**State of California**  
**DEPARTMENT OF JUSTICE**

July 11, 2022

RE: Draft Environmental Impact Report for the Stoneridge Commerce Center Project (SCH #2020040325)

### Exhibit A: Annotated Maps of the Primary and Southern Truck Routes

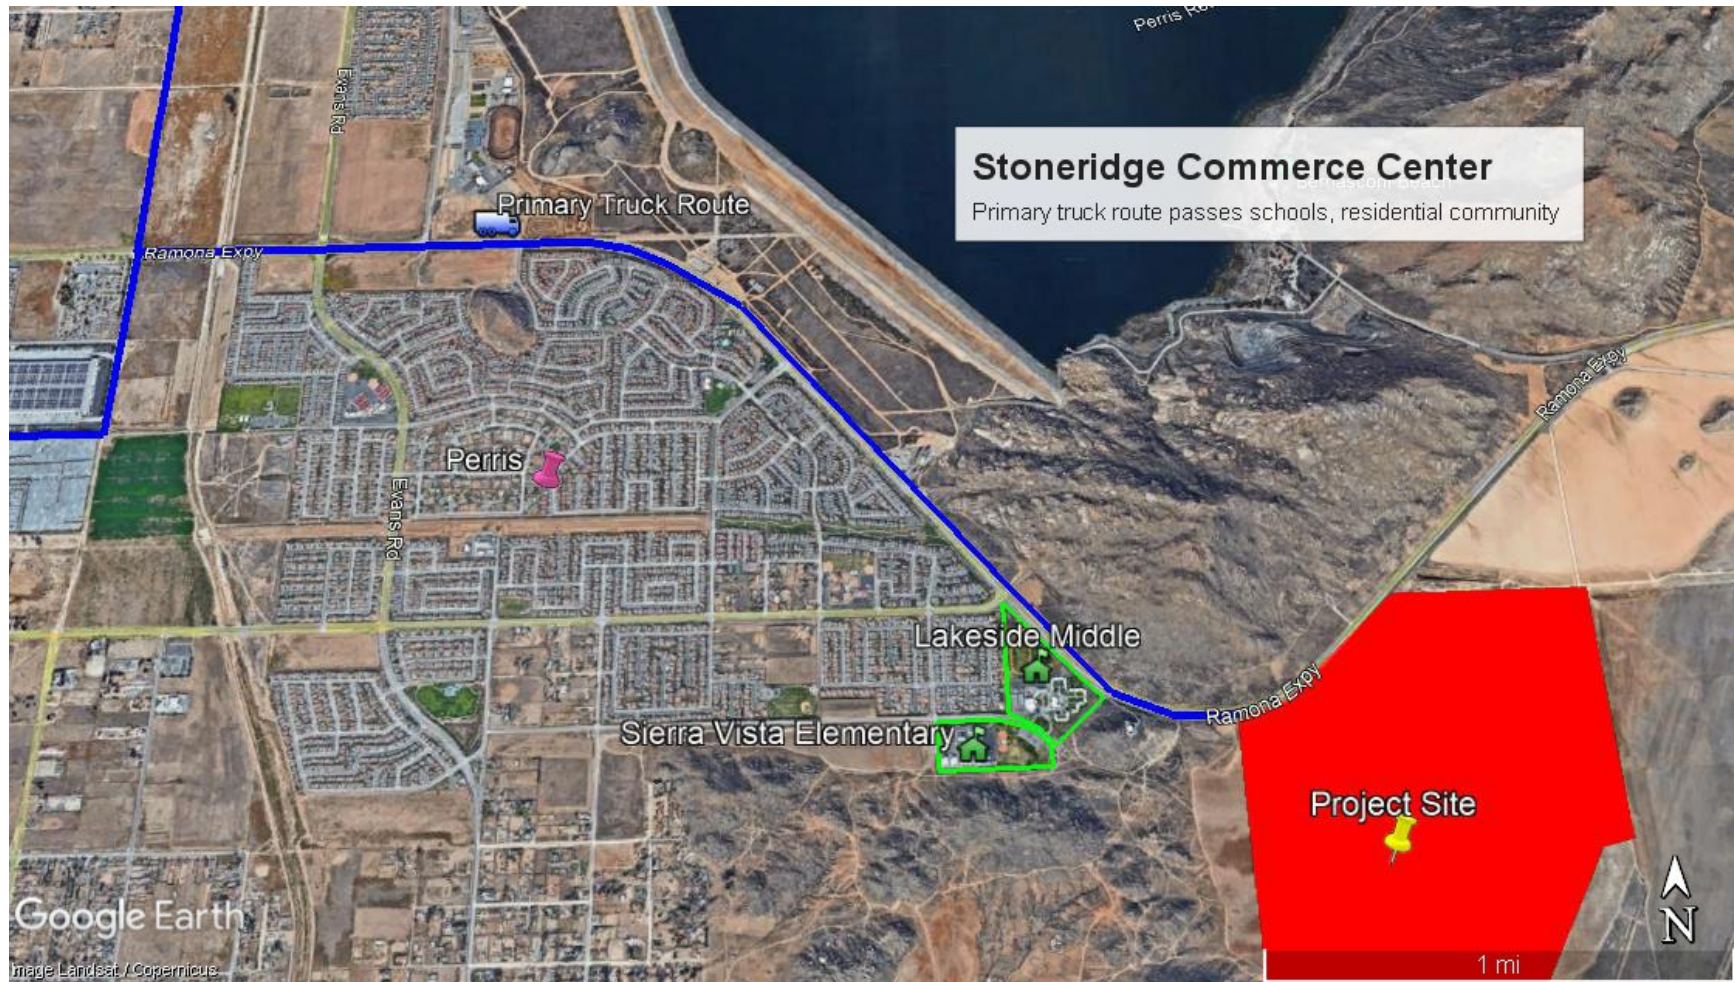
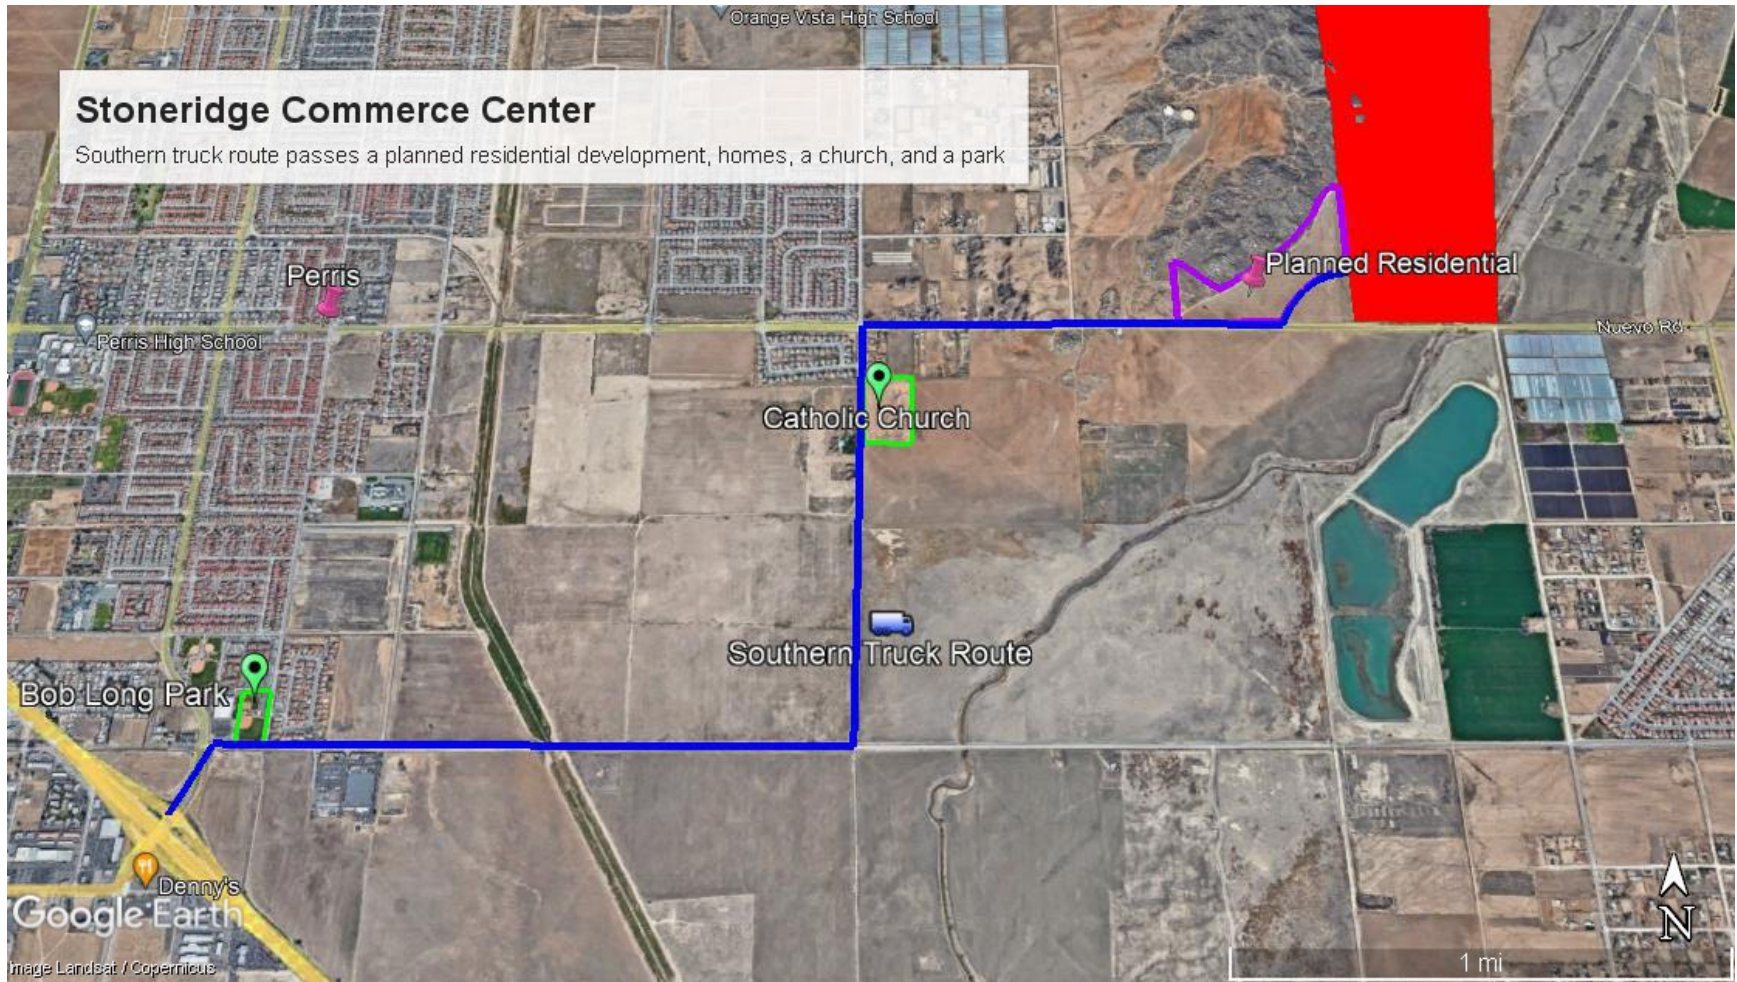
The Project would construct one of the largest single warehouse complexes in California: over 9.5 million square feet of total warehouse space<sup>2</sup> and over 120,000 square feet of new retail commercial space on 582.6 acres.<sup>3</sup> The DEIR projects that the Project will generate 3,916 daily heavy-duty truck trips—an average of one truck every 22 seconds over the expected 24/7 operation of the warehouse complex.<sup>4</sup> The DEIR analyzes two different truck routing plans, each of which would involve a lengthy path to the highway past homes and other sensitive receptors. The Primary Truck Route plan would direct 98 percent of the Project's truck traffic along a six-mile route to the highway via Ramona Expressway, which borders Lakeview Middle School and a substantial residential community in Perris.<sup>5</sup> The Southern Truck Route plan would still direct 60 percent of trucks (2,350 trucks daily) along Ramona Expressway, but 38 percent (1,488 trucks daily) would take a four-mile path via Nuevo Road, passing a planned residential development called McCanna Hills, two smaller residential communities, a church, and a public park.<sup>6</sup> Annotated satellite images showing the truck routes and Project vicinity are attached to this letter as Exhibits A and B.

The DEIR proposes two alternative truck routes to accommodate the Project's nearly 4,000 expected daily truck trips, both of which would lead to thousands of daily truck trips passing residences and sensitive receptors.<sup>47</sup> The Primary Truck Route plan would direct 98 percent of the Project's truck traffic along a six-mile route to the highway via Ramona Expressway, which borders Lakeview Middle School and a large residential community in

Perris.<sup>48</sup> The Southern Truck Route plan would still direct 60 percent of trucks (2,350 trucks daily) along Ramona Expressway, but 38 percent (1,488 trucks daily) would take a four-mile path via Nuevo Road, passing the planned residential development of McCanna Hills, two smaller residential communities, a church, and a public park.<sup>49</sup>

In addition to inadequately analyzing the adverse impacts to air quality and noise that these truck routes pose for sensitive receptors, as described above, the DEIR has incorrectly assumed that trucks on the Primary Truck Route would use the Ramona Expressway to access Interstate 215 in the east. The City of Perris, through which that stretch of Expressway traverses, has removed that portion of the Expressway as a truck route. According to Perris, the City removed the “entire stretch of Ramona Expressway as a truck route” under the Perris Valley Commerce Center Specific Plan, which the City adopted in January 2012, thus removing an approximately 2.5-mile stretch of Primary Truck Route located within Perris’s city limits along the Ramona Expressway.<sup>50</sup> As such, in accordance with Perris’s restriction, 98 percent of the Project truck traffic based on the Primary Truck Route plan, or 60 percent of the Project truck traffic based on the Southern Truck Route plan, is not viable.

The DEIR should therefore reconsider the truck routes it proposes to service the Project site to avoid the Ramona Expressway. One alternative is to redirect most of the truck traffic to the south; but instead of using the path planned under the Southern Truck Route, a new southern route could be used to divert trucks away from the sensitive receptors along the Southern Truck Route (the planned residential development of McCanna Hills, the two smaller residential communities, the church, and the public park). The alternative southern route would require the expansion in capacity of existing roads and the construction of a new highway interchange. For example, Dawson Road, whose northern terminus does not intersect any existing roads, could be extended to intersect with Nuevo Road to divert truck traffic south along Dawson Road immediately after departing the Project site. Trucks could then head west on San Jacinto Avenue, south on Dunlap Drive, followed by west on Ellis Avenue. To accommodate truck traffic onto Interstate 215 without routing trucks past major sensitive receptors, the County could consider the construction of an Interstate 215 highway interchange at Ellis Avenue, subject, of course, to approvals from Riverside County Transportation Commission and other relevant municipalities and agencies.

**Exhibit B: Annotated Map of the Project Vicinity**

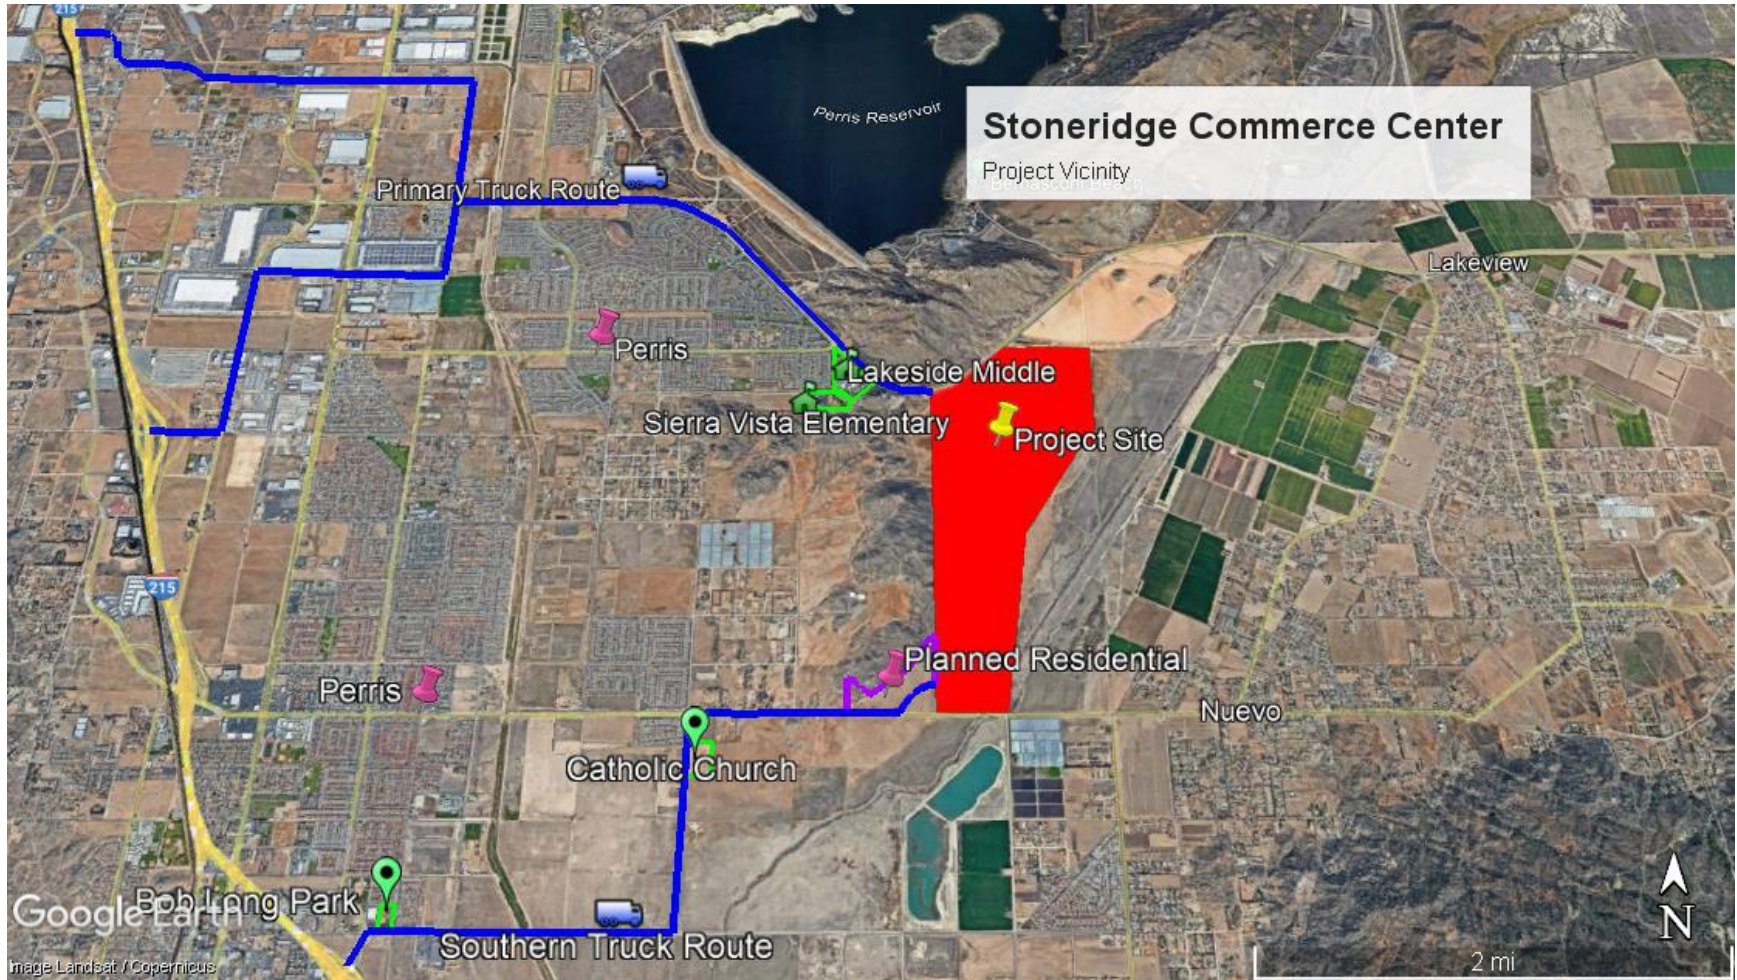
The Project would primarily impact three communities in Perris: the community bordering Ramona Expressway, the communities along the Southern Truck Route, and the planned McCanna Hills community. Ramona Expressway forms the northern border of a large residential community in Perris. Homes back up to Ramona Expressway along the entire 1.5-mile stretch from Rider Street to Avalon Parkway. The homes are slightly recessed into the ground, such that Ramona Expressway is approximately level with the homes' second stories. A short wall separates the homes from the road, but the wall does not shield second story windows

# Exhibit C: McCanna Hills Specific Plan Map

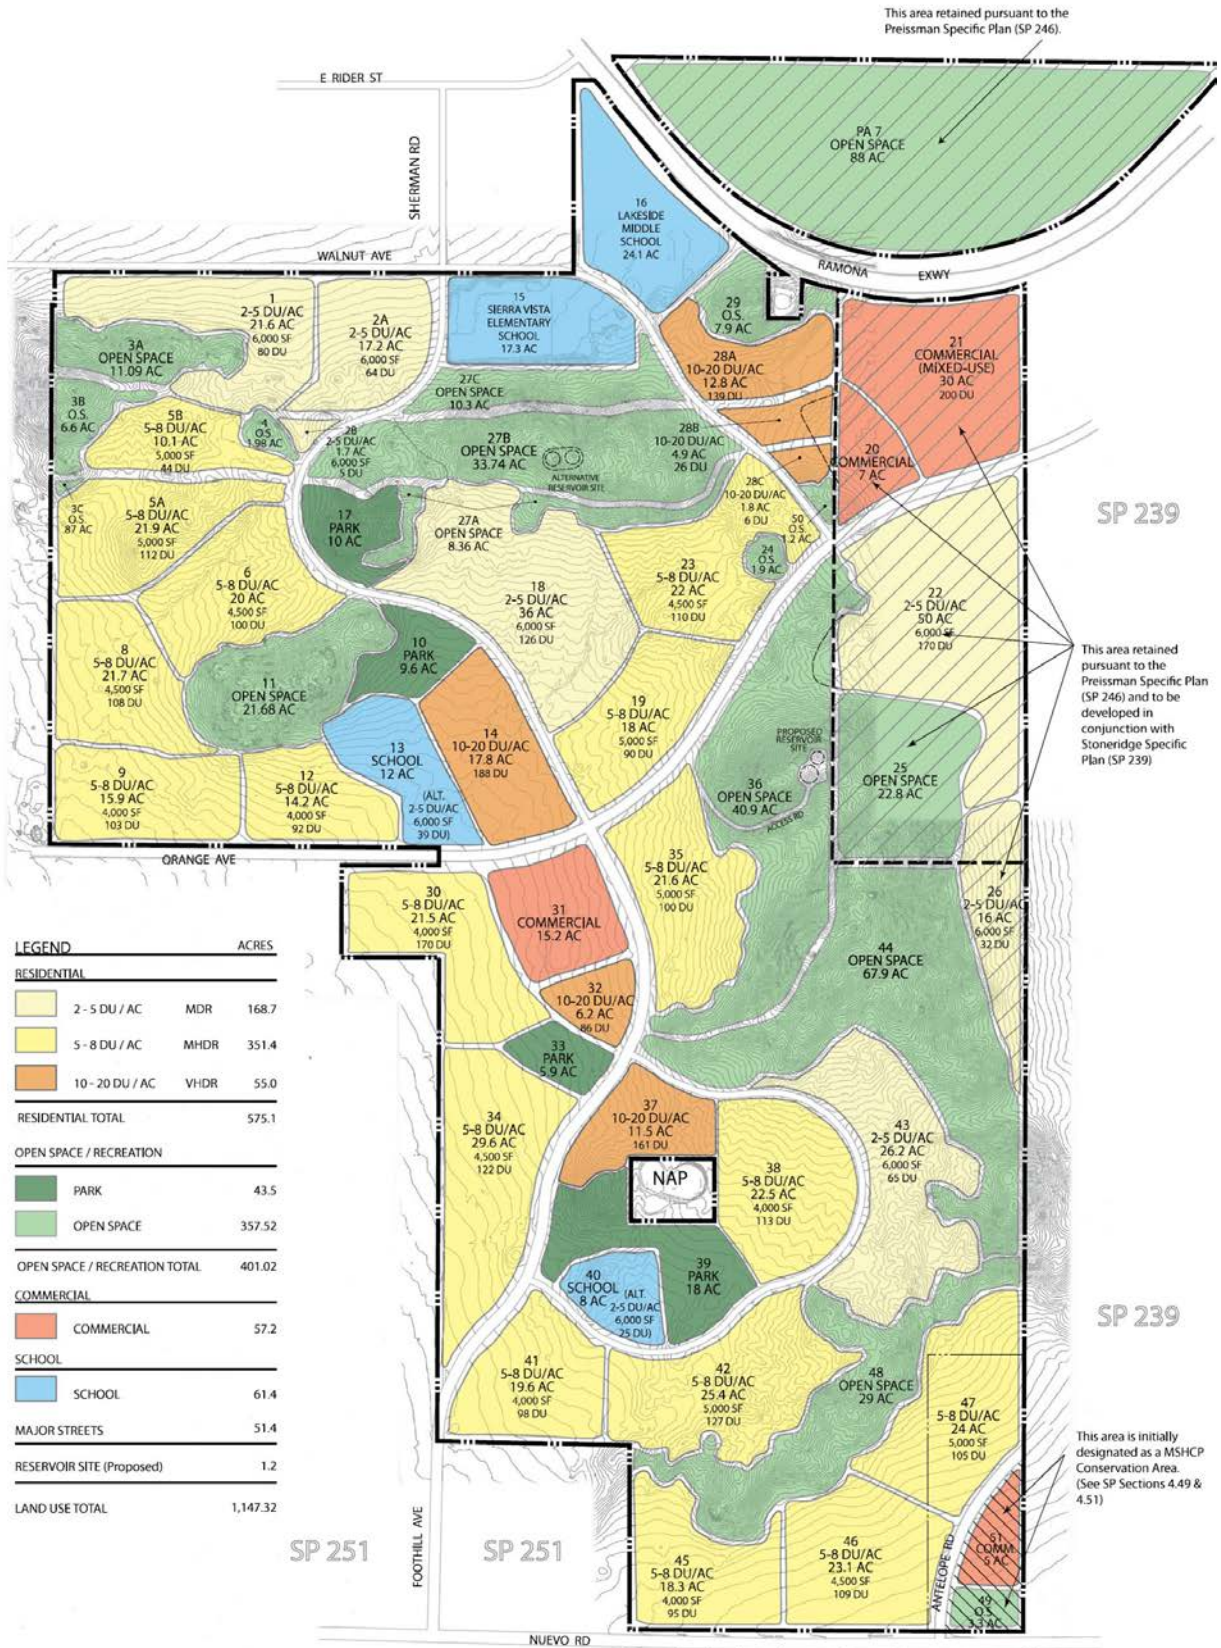
Finally, the McCanna Hills Specific Plan is an approved but unconstructed development that would be sited west of the Project site and south of the community bordering Ramona Expressway (see Exhibit C). The McCanna Hills development shares its eastern edge with the western border of the Project site. Active permits exist to build on several planning areas, including two that would construct new housing north of Antelope Road and Nuevo Road, adjacent to the Project site and along the first section of the Southern Truck Route.<sup>10</sup> If those units are ultimately constructed and occupied, the Project would impact a substantial number of additional sensitive receptors. The Project would also directly affect several other planning areas in the McCanna Hills Specific Plan without active permits, including a third planning area along Nuevo Road, designated open space bordering the Project, and higher-density residential and open space along Ramona Expressway.<sup>11</sup>
